DRAINAGE STRATEGY PEER REVIEW

Lincoln Heath South PSP1207.1

June 2015

Figure 2. PSP1207.1 sub-catchment plan

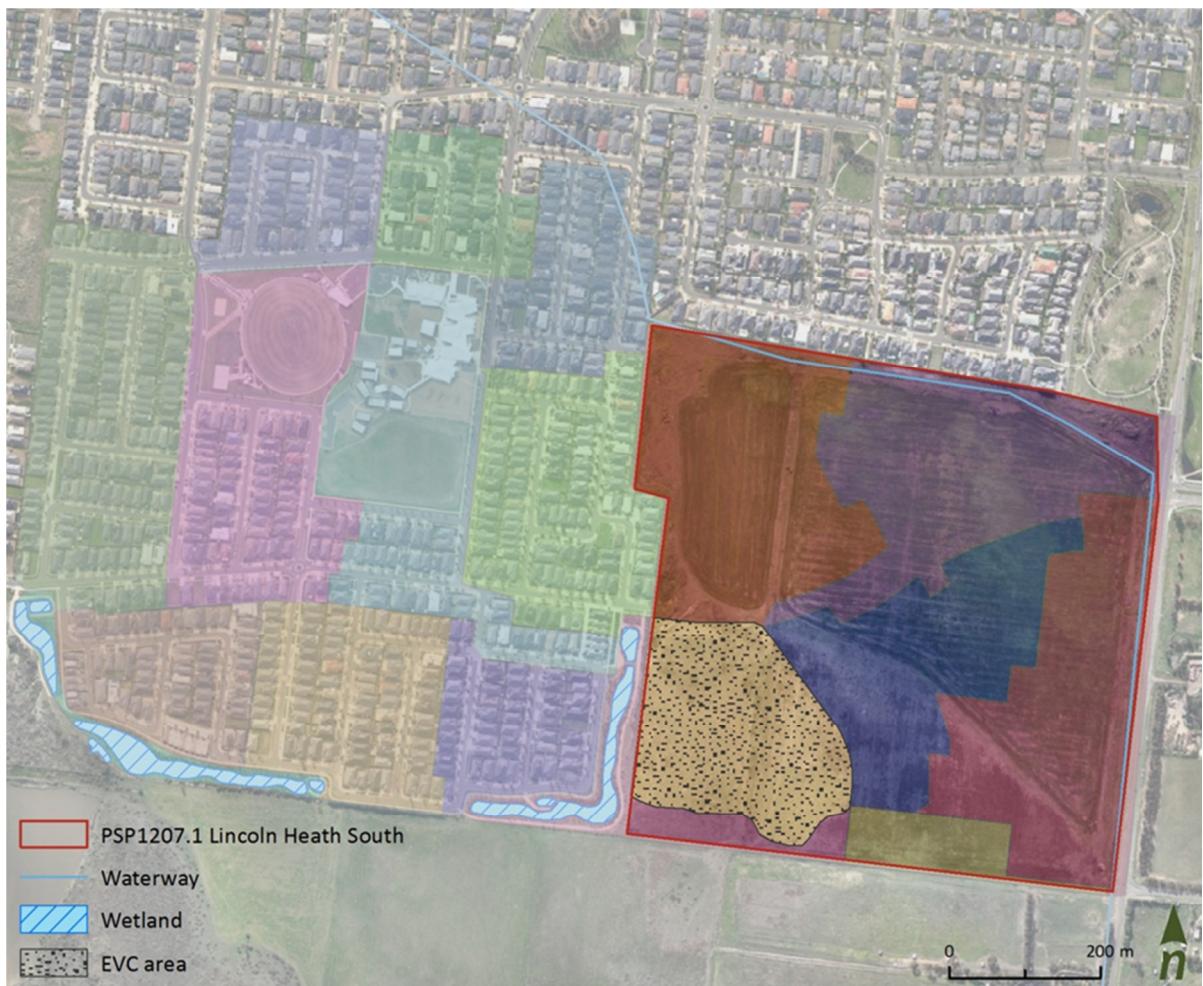
Figure 2 illustrates the sub-catchments within the Lincoln Heath South PSP. Of note is the ecological vegetation class (EVC) wetland area that is intended to be preserved as part of the PSP in the south west corner. Proposed locations for sediment basins and wetlands are along the PSPs southern boundary. Figure 2 also highlights the location of Alamanda wetlands to the west of PSP1207.1.

Figure 3. PSP1207.1 RORB modelling sub-catchment plan

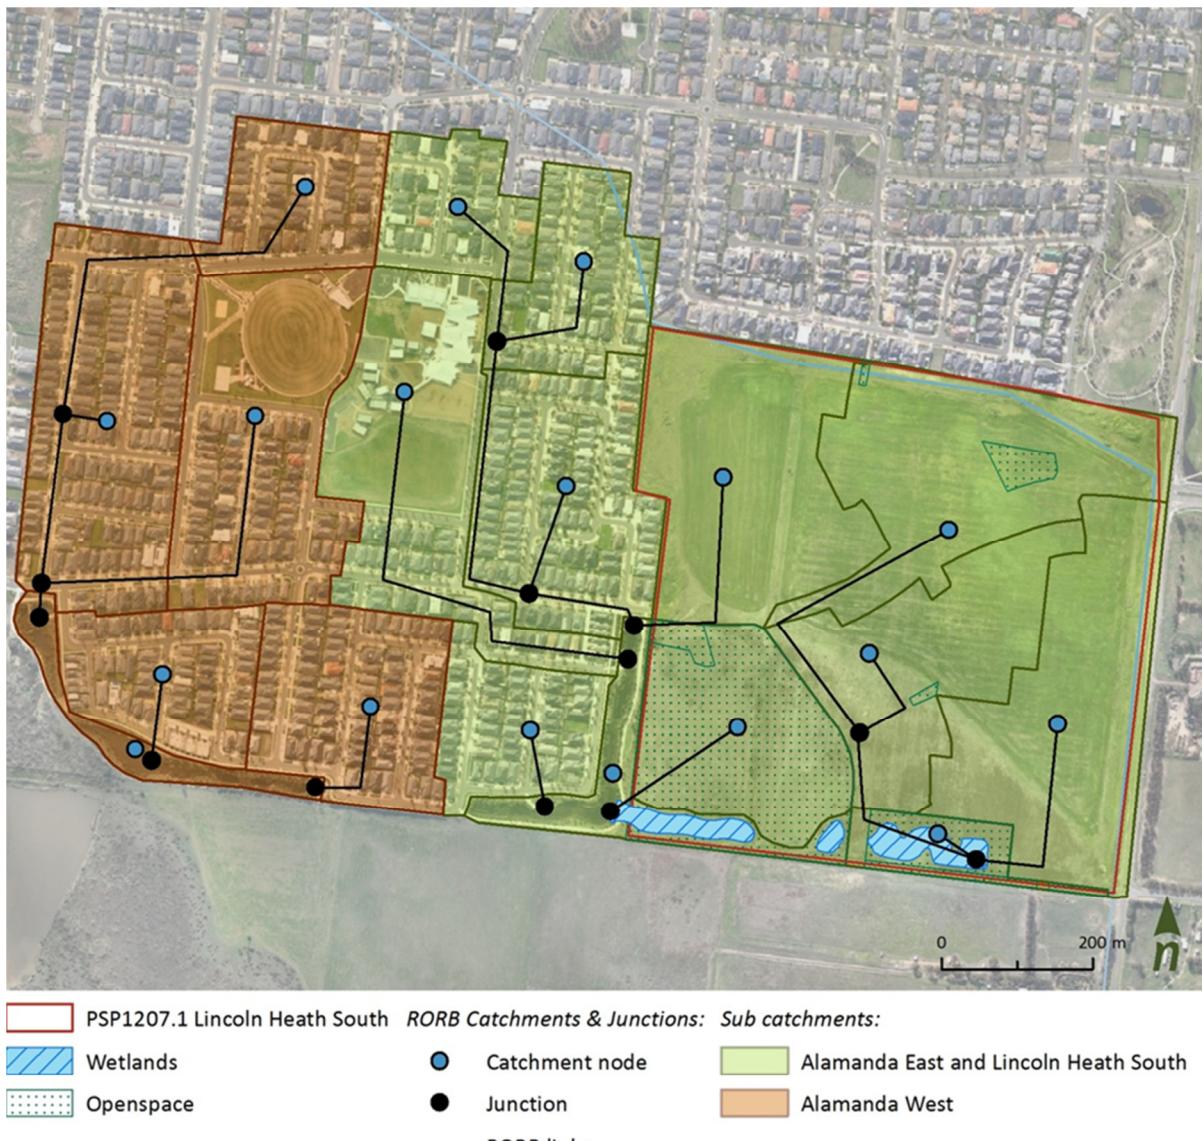
Using contour data and plans of the surrounding drainage network, sub catchments were delineated as per Figure 3. This shows the PSPs eastern sub catchments draining to the two main sediment basin and wetland cells along the PSPs southern boundary. The north western sub catchment is modelled to drain to the sediment basin and wetland cell running north-south along the eastern boundary of the Alamanda Estate. As a result wetlands within PSP1207.1 were increased in size to compensate for the stormwater flows that are diverted to and treated within the Alamanda Estate.

- 12 sub catchments ranging from 1.8 to 9.4 ha that were defined for PSP1207.1 and for the east of the Alamanda Estate; and
- Six sub catchments ranging from 1.6 to 9.8 ha defined for the west of the Alamanda Estate.

Figure 4. RORB inflow locations

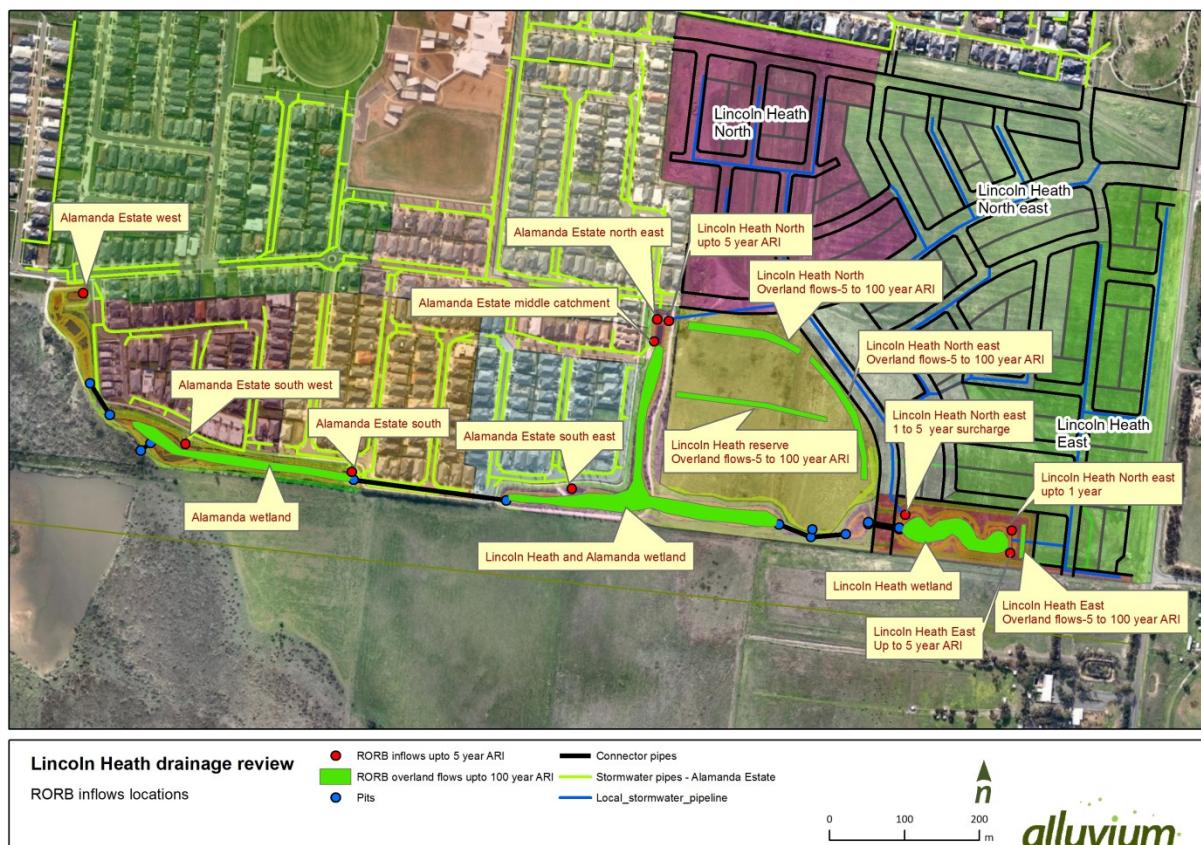
Based upon the proposed drainage system for Lincoln Heath South as described in the Craigie Strategy and the existing drainage network in Alamanda Estate, a hydrograph was calculated for each catchment inflow point to the basin system. The location of these inflows into the 2D hydraulic model is shown in Figure 4.

Figure 11. Recycled water main alignment (Source: City West Water)

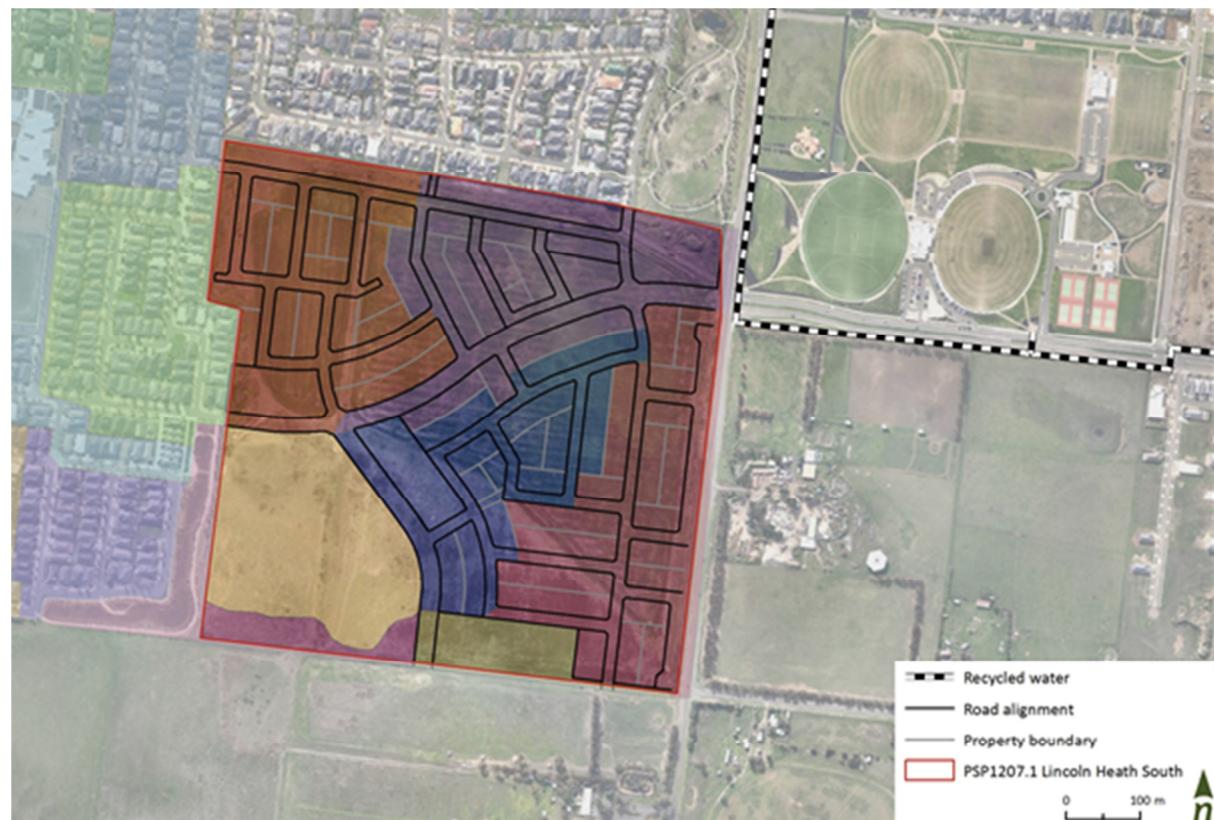
City West Water have confirmed that a recycled water pipeline (225mm) travels along Sneydes Road before turning into Point Cook Road where the diameter is reduced to 150mm. The pipeline supplies Class A recycled water with a total dissolved solids concentration of approximately 1000mg/L that is suitable primarily for irrigation use (Figure 11).

City West Water suggests that the supply from this main is constrained, so the purpose of this work is to estimate irrigation demand for the estimated open space and consider if there may be sufficient capacity to supply that open space. At the point where the recycled water main turns east they have supplied pressure and flowrate information indicating that in summer, when the recycled water supply is experiencing higher demand, maximum flowrates of 10 l/s (at 40m head or pressure) or 20 l/s (at 30m head) are potentially available.

Figure 12. Seasonal average daily demand

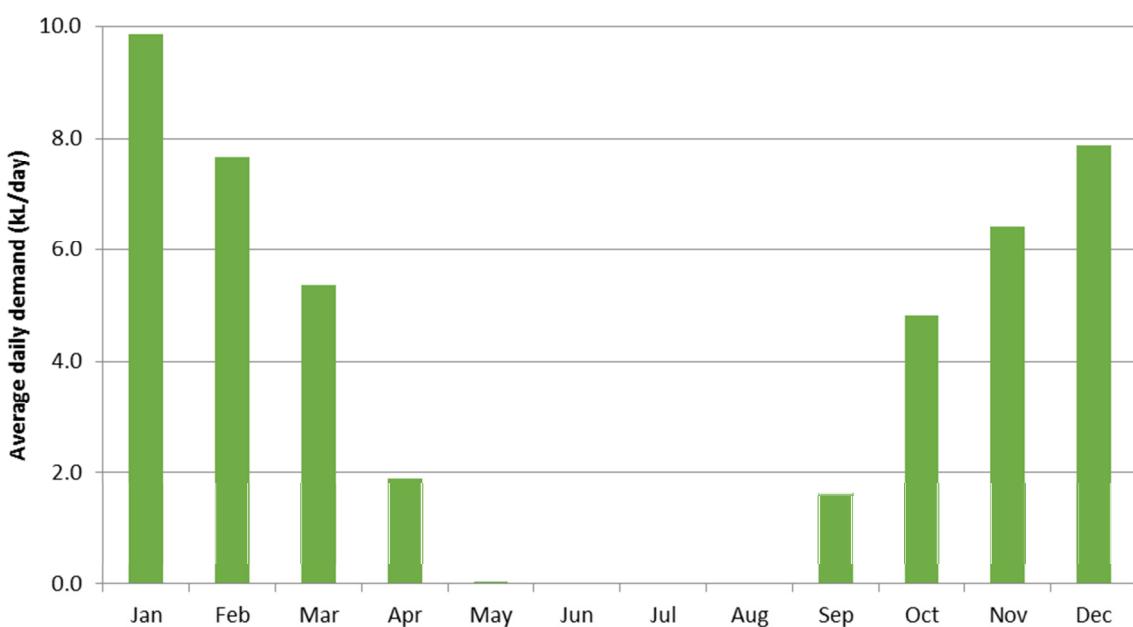
If recycled water were to be extended to the Point Cook South PSP, the intention would be to irrigate that PSPs open space. Providing third pipe to residences is not being considered. Based on plans provided by MPA it is estimated that the PSPs open space area is approximately 0.4 ha. Irrigation demand analysis was completed, taking into account suitable crop factors for warm season grass, passive use and irrigation efficiency of 75% to determine seasonal irrigation demand. In summary, irrigation demand was estimated at 3.5 ML/ha/year with seasonal average daily demand (in kL/day) summarised in Figure 12.

This result indicates that an average summer demand of approximately 10kL / day. If we assume that an irrigation cycle takes one hour then a demand of approximately 3 l/s is required. Based on the information provided by City West Water this could be theoretically possible if the recycled water main could be extended the approximately 150-200m to the indicative location of the open space in MPA's preliminary plans. Further, based on the relatively flat topography pressure of 30m is considered sufficient to satisfy irrigation requirements.

It is proposed that the results of this initial analysis be discussed with City West Water and Council to understand how such a proposal would integrate with broader strategic plans and if further system modelling is required.
